PHASE II REMEDIAL INVESTIGATION

**INSTALLATION RESTORATION STUDY
NAVAL SUBMARINE BASE - NEW LONDON
GROTON, CONNECTICUT**

RE: Phase II Remedial Investigation
Atlantic Project No.: 1256-18

**NAVY RESPONSES TO EPA COMMENTS (MAY 5, 1993)
ON THE REVISED DRAFT PHASE II
REMEDIAL INVESTIGATION WORK PLAN (MARCH 1993)**

FIGURE 2-12

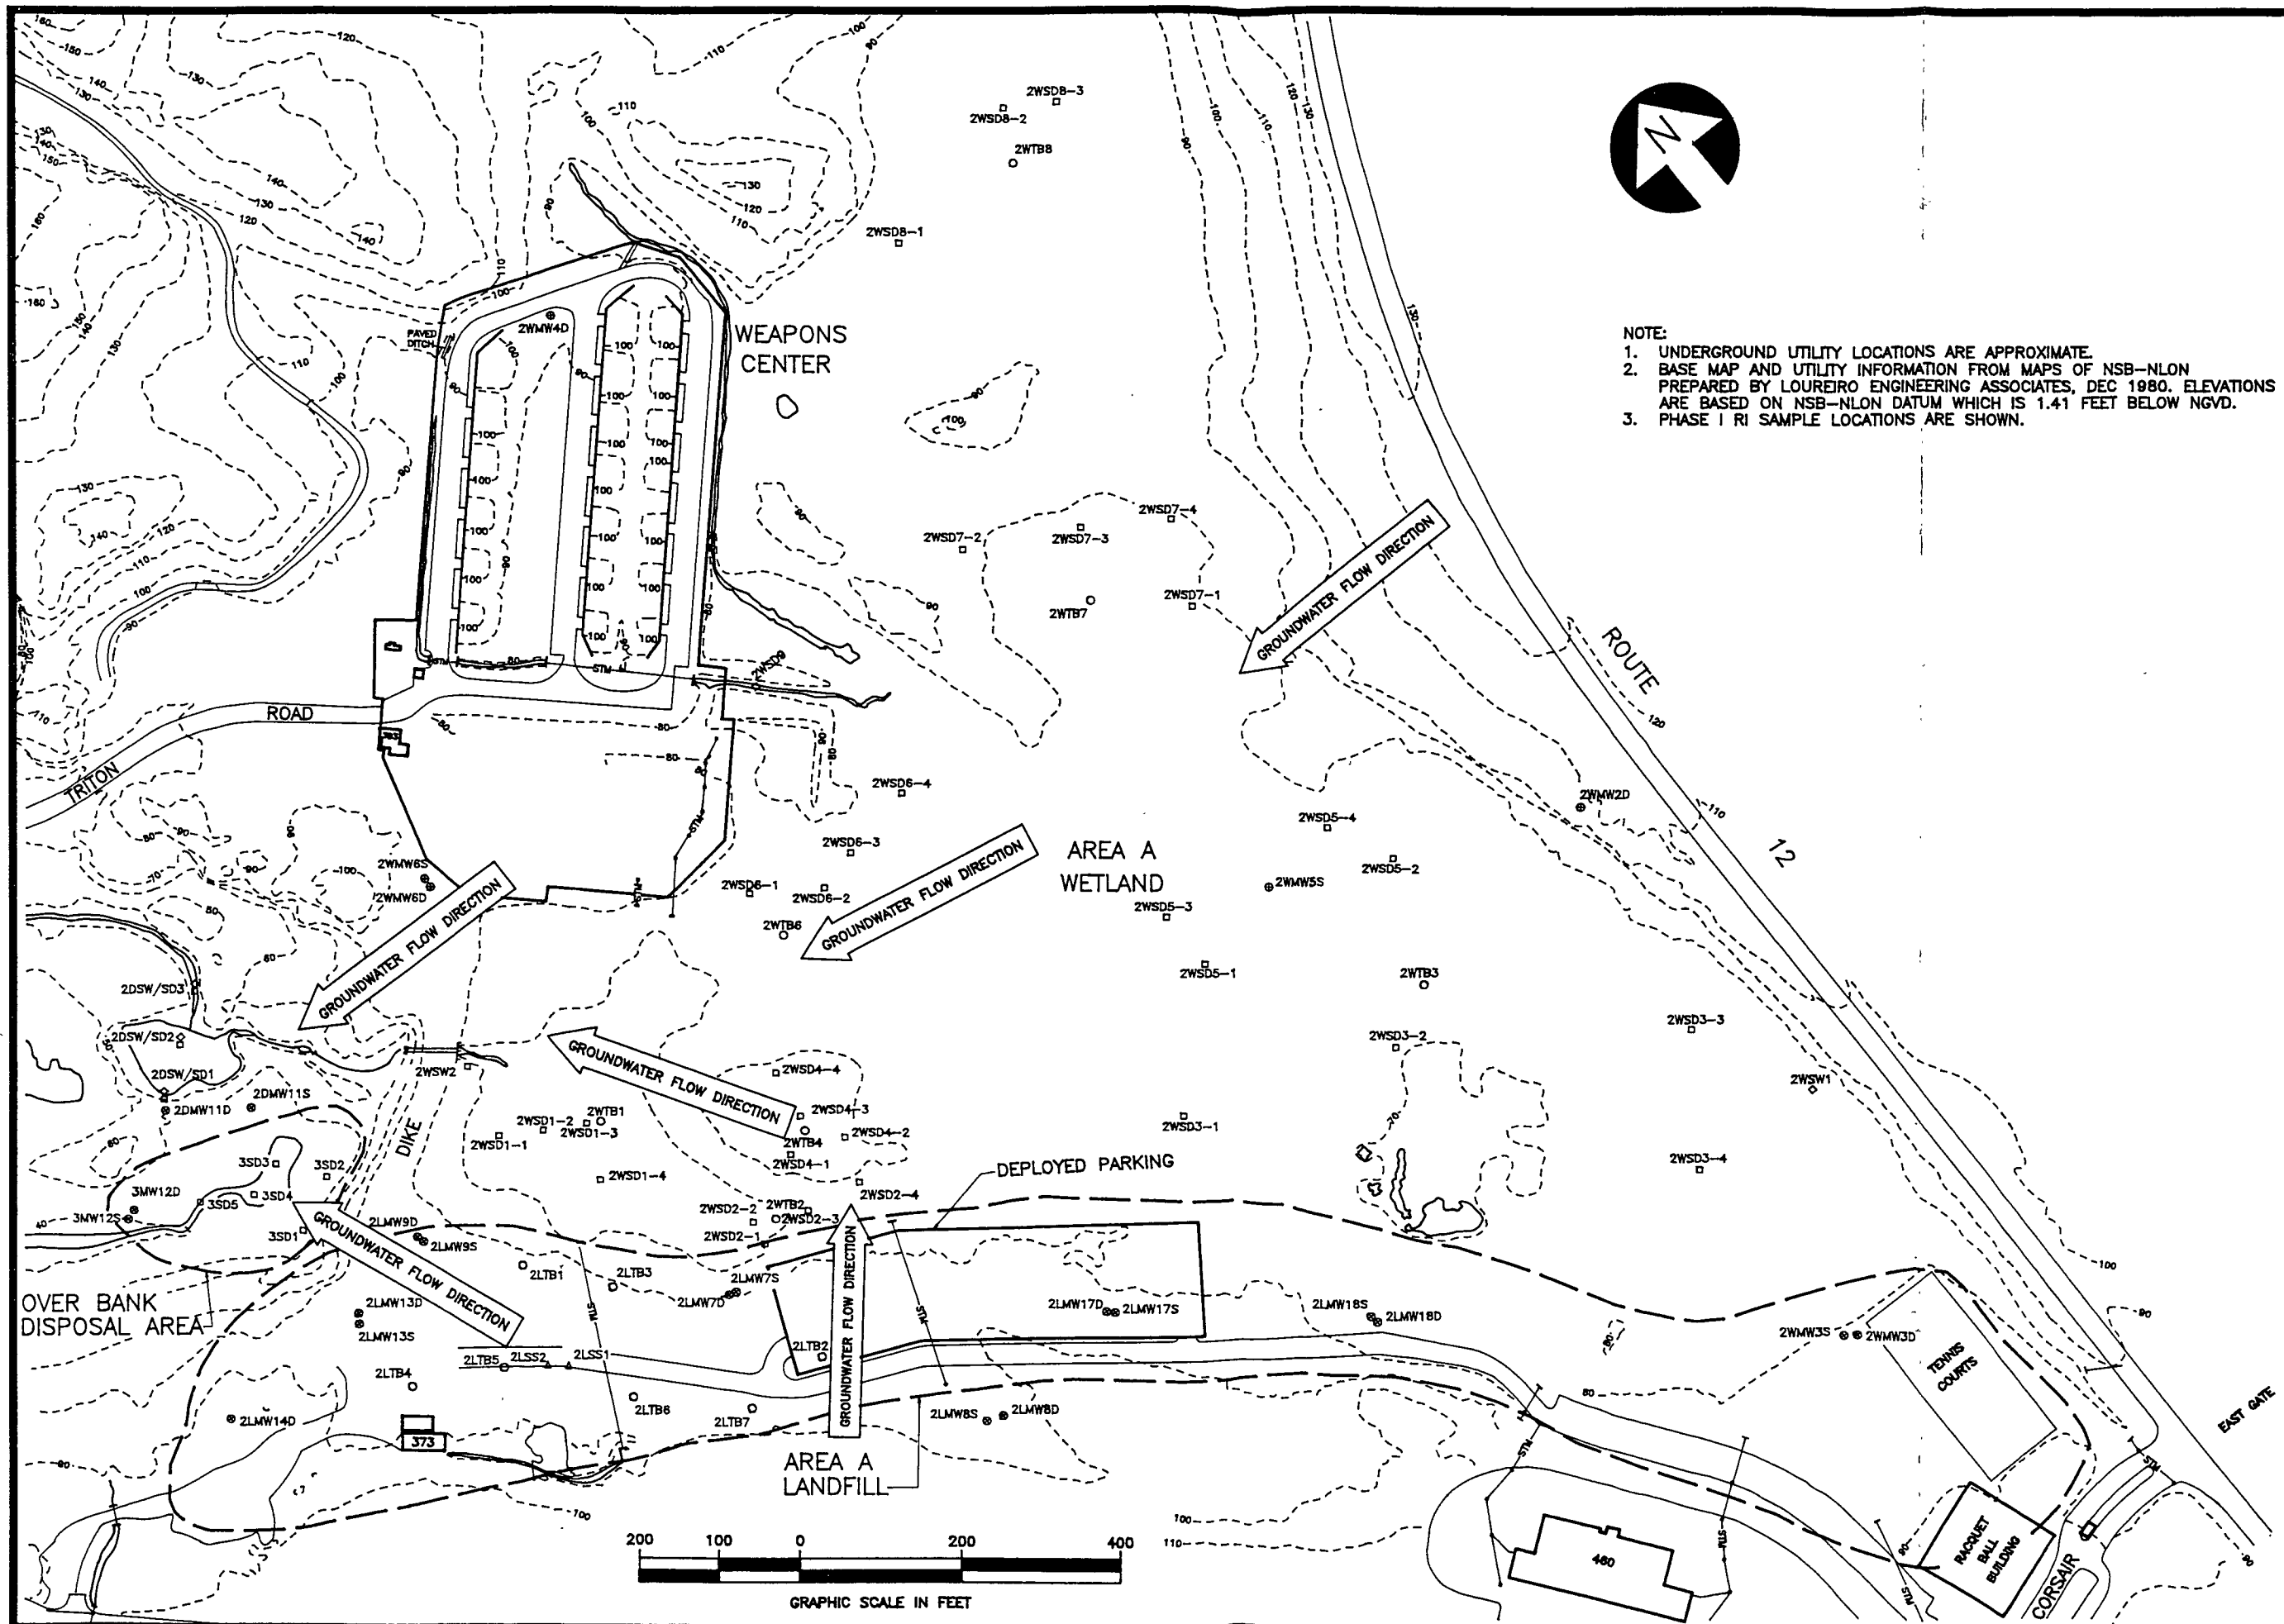
It is unclear where Building 524 is located. Please depict its location on Figure 2-12.

Due to the scale of Figure 2-12, Building 524 cannot be shown in this figure. It will be added to Plate 1 and the text will be revised accordingly.

FIGURE 2-15
SITE PLAN
LOWER SUBASE

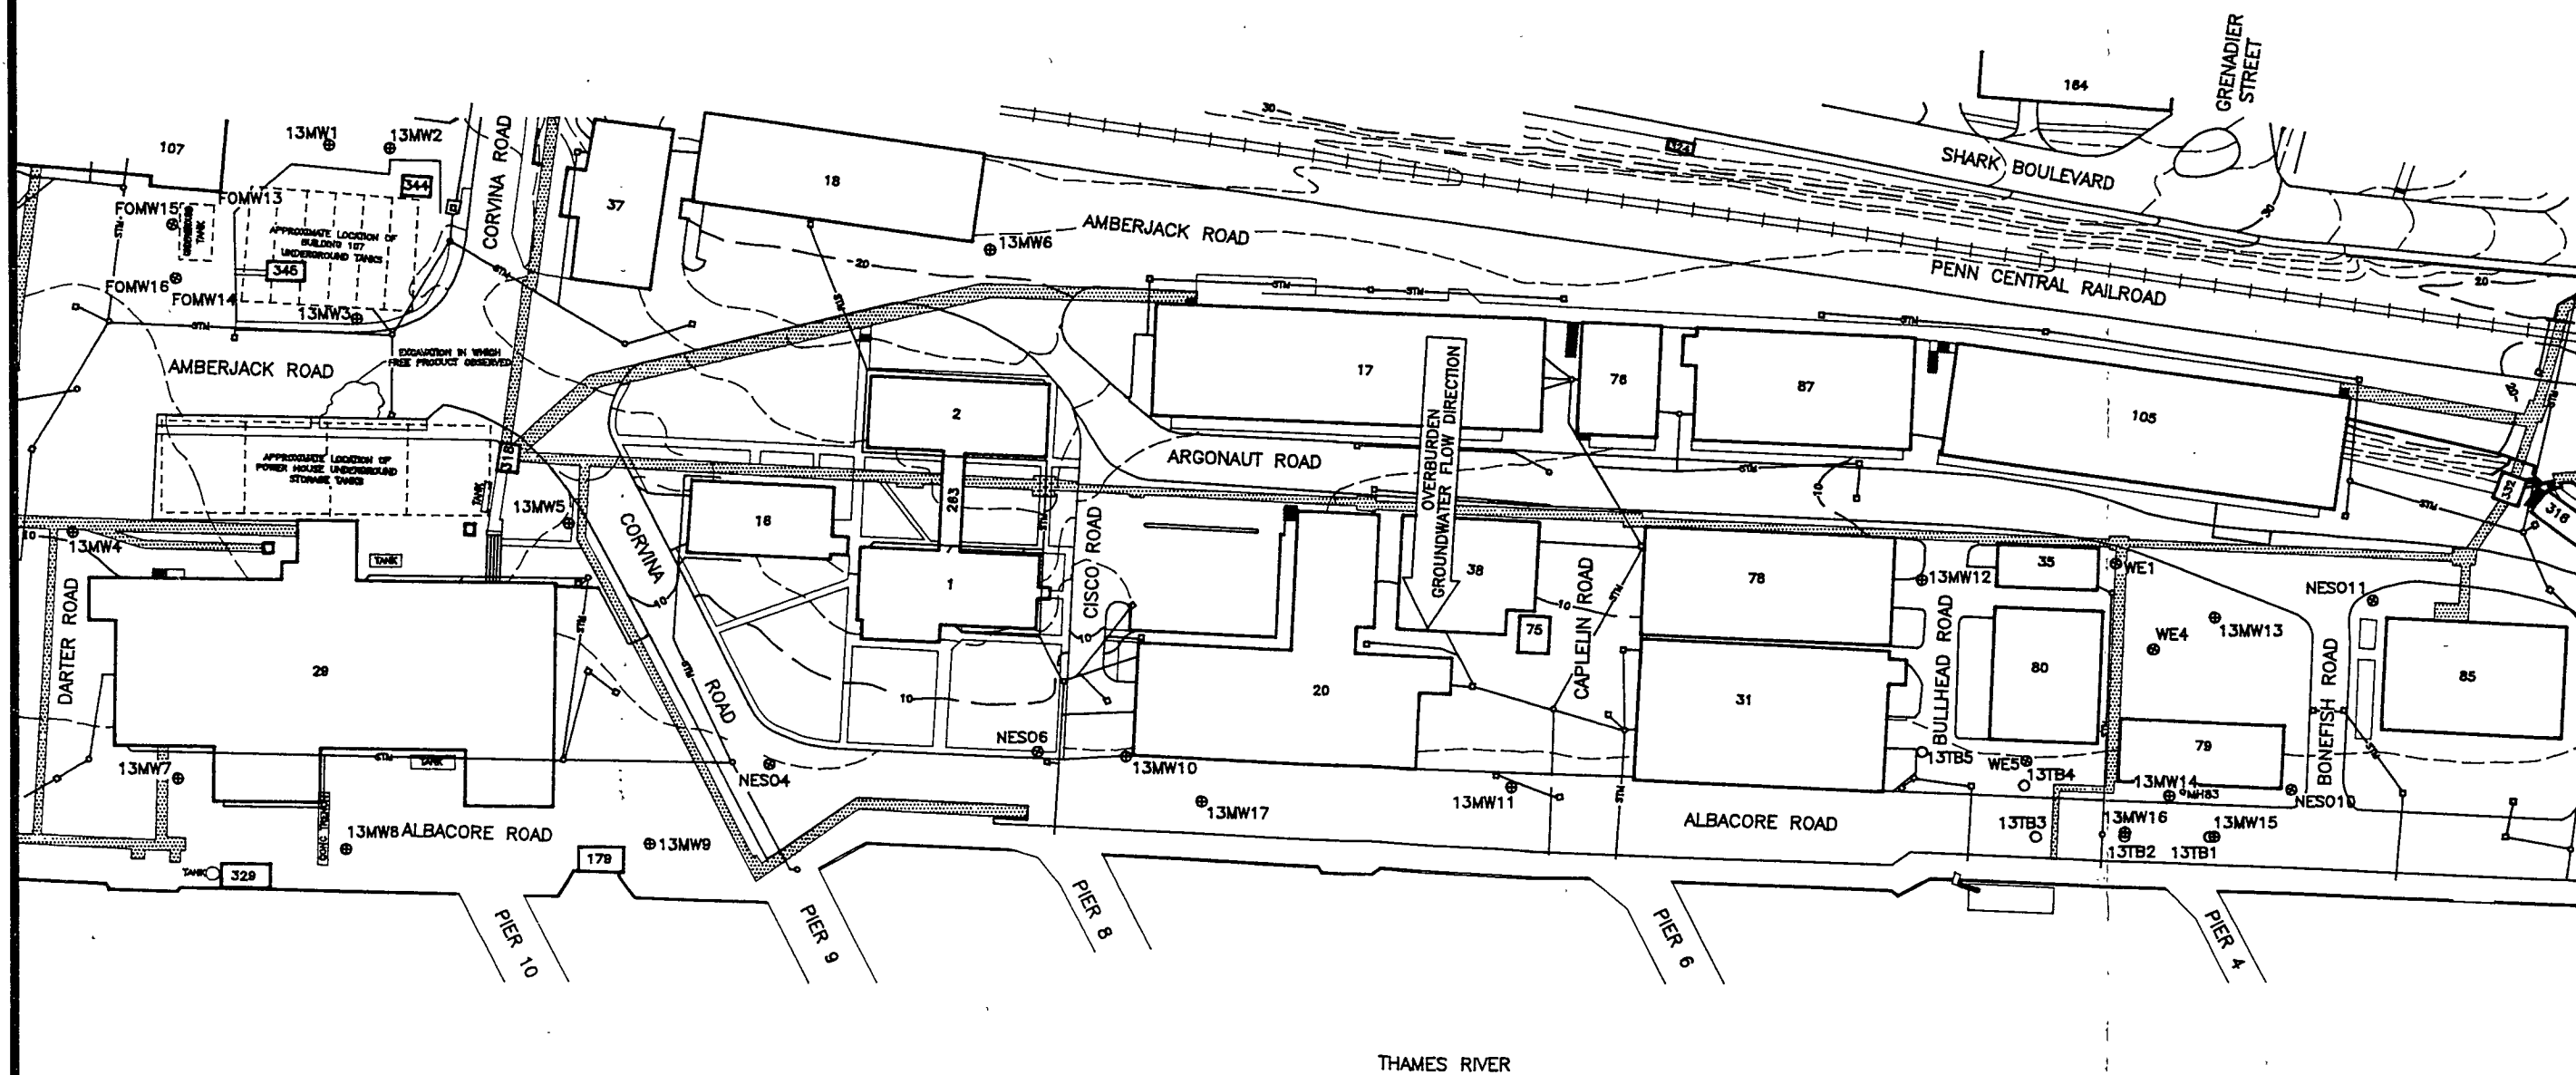
Present the location of MH83 on Figure 2-15.

Manhole MH-83 will be shown in Figure 2-15.

FIGURE 3-4
SPENT ACID STORAGE AND
DISPOSAL AREA
CONCEPTUAL SITE MODEL

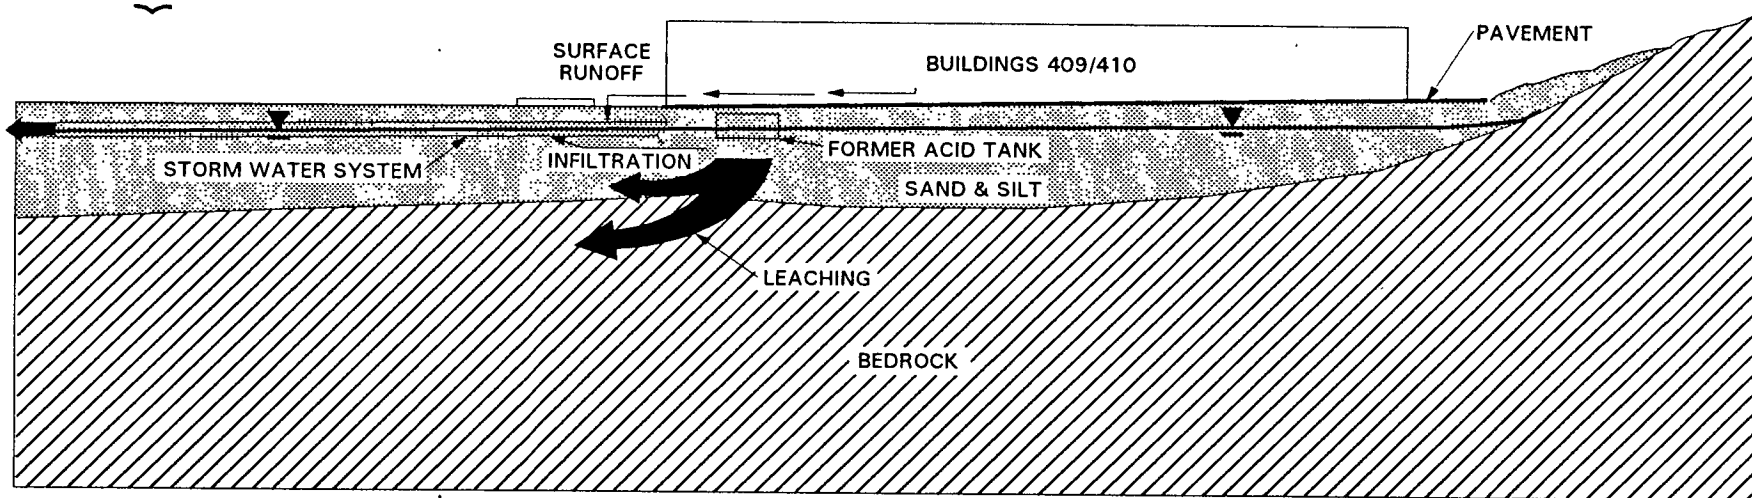
Revise the work plan to include a bedrock monitoring well to evaluate the transport pathway indicated in the conceptual model (Figure 3-4). In addition, provide the rationale used to select the locations and depths from which samples will be collected for analysis of engineering properties.

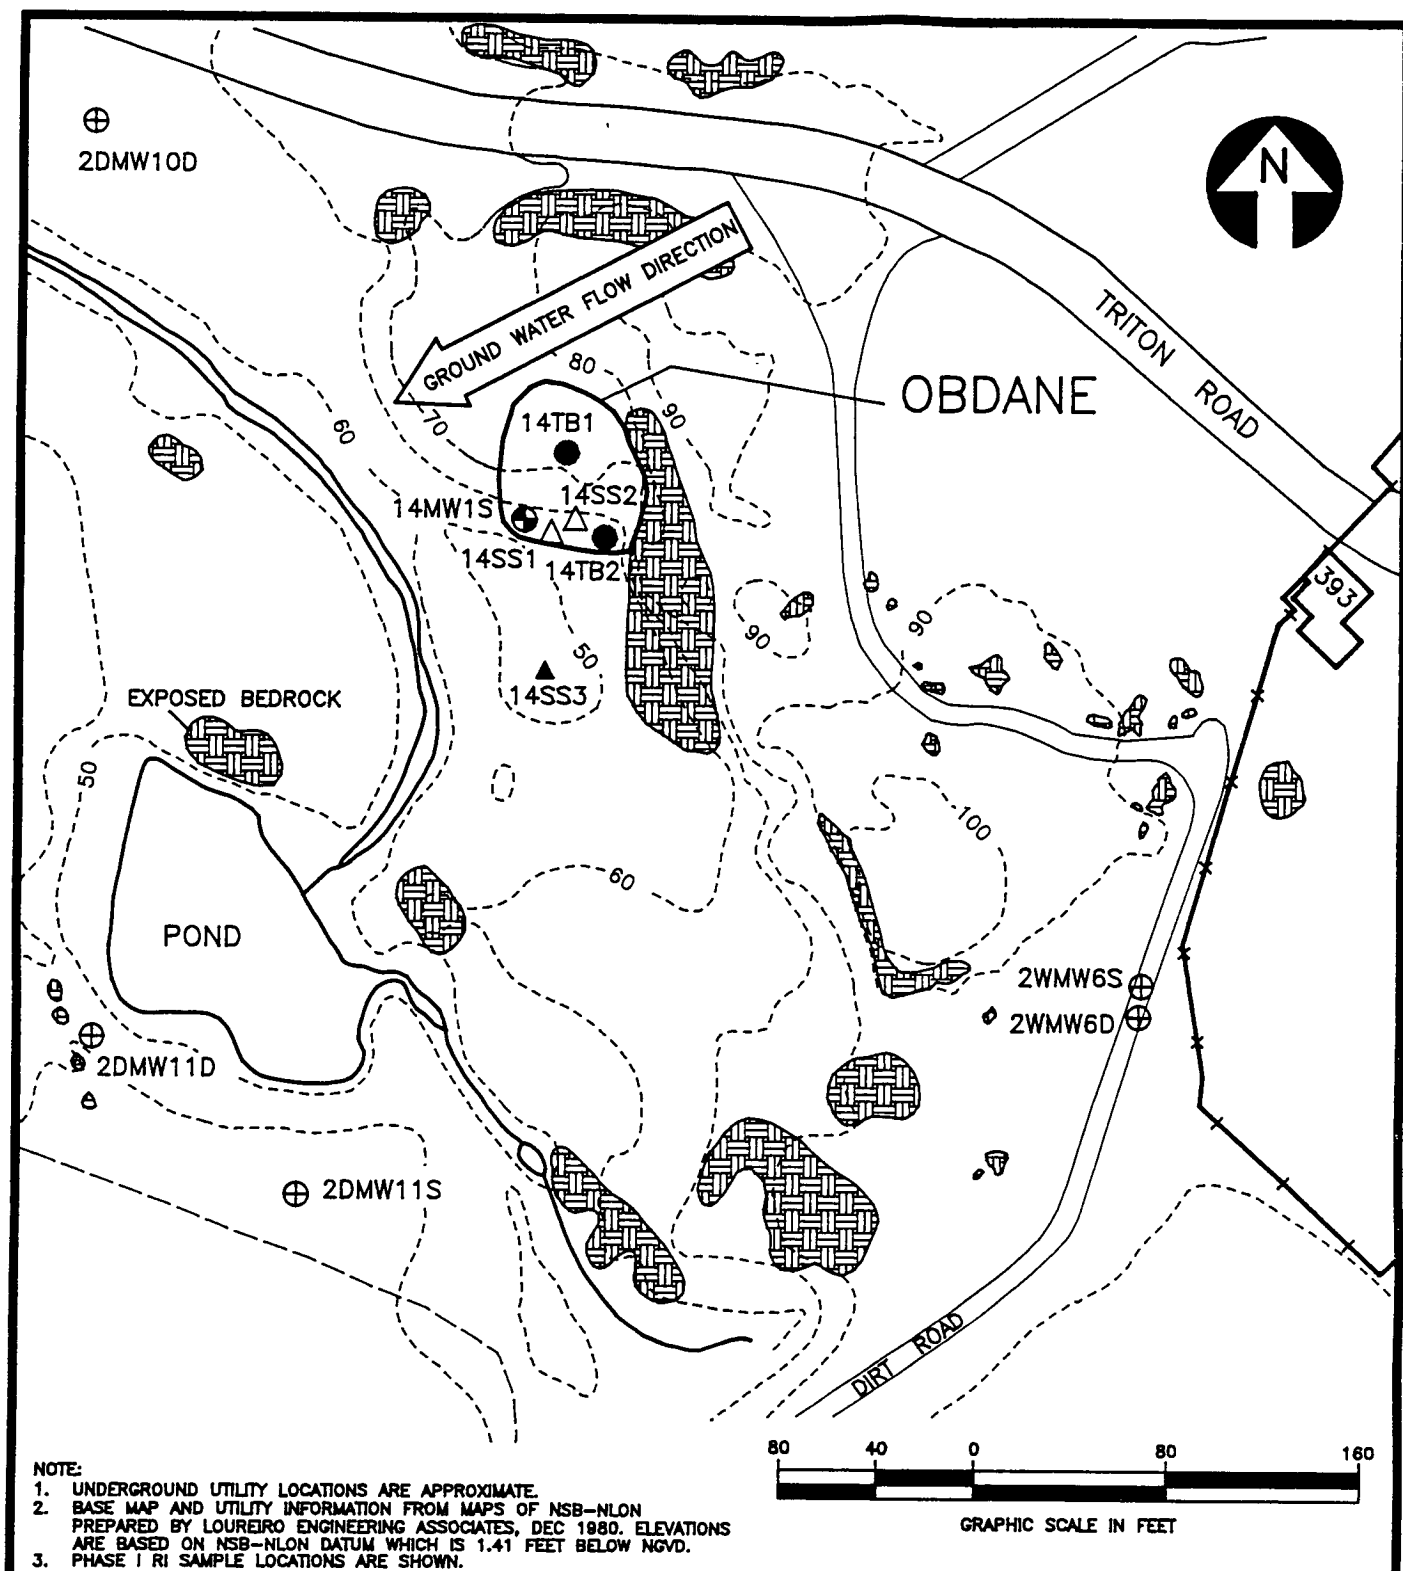
19. Page 176, Figure 7-2 — OBDANE Field Sampling Plan
